SUBJECT: Invitation for Bid (IFB #11-1591-OV
Samoset Area / Sidewalks / Drainage
(A/K/A: Central County Infrastructure Improvement Project)
Manatee County Project No. 9012109 1.1)
Manatee County, FL

ADDENDUM #3

RE: Addendum 3
Samoset Improvement Area Sidewalks – Manatee County, Florida
CSDG Project # 17873.04

MANATEE COUNTY PUBLIC WORKS DEPARTMENT
STA. 28+00 TO STA. 30+00

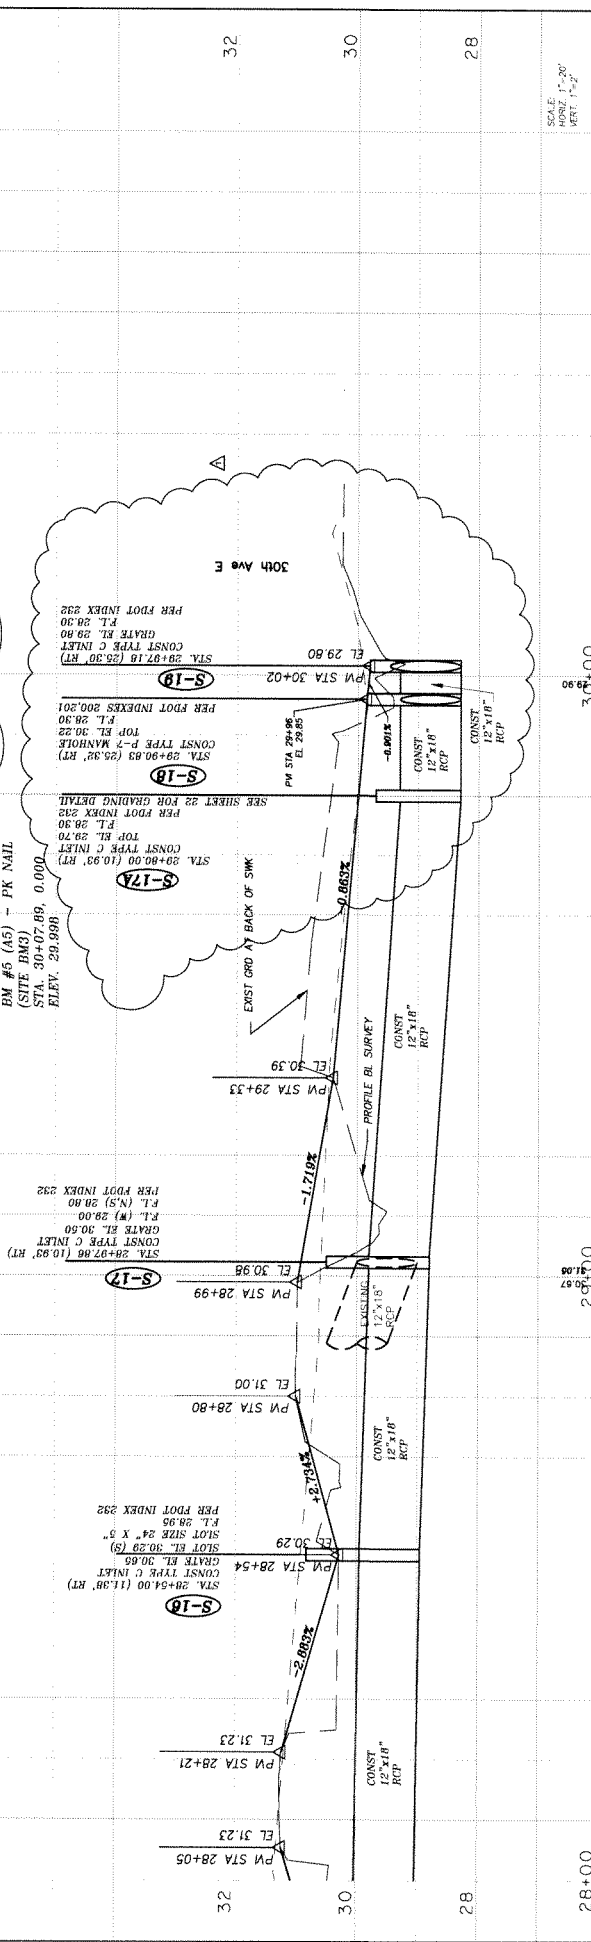
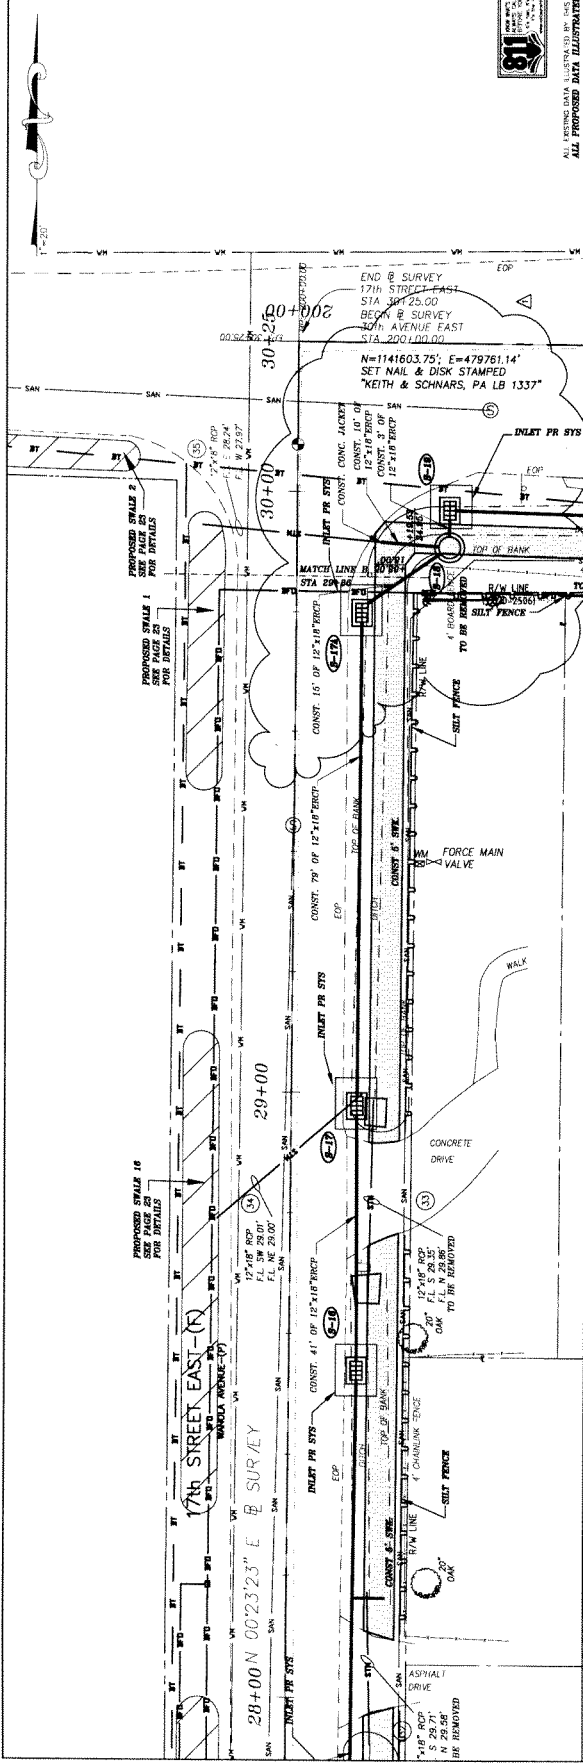
Question Many of the structures for the project lack the required height in order to fit the piping into the structure – i.e. #4, 5B & 18 to . Will there be an allowance made for monetary adjustment in the pay item if structures are revised during the shop drawing submittal process?

Response *No allowances will be made for monetary adjustment in the pay item if structures are revised during the shop drawing submittal process. The following are adjustments to the plans for the previously mentioned structures:*

18 Structure 18 has been relocated for constructability; see attached revised Plan sheet 10.
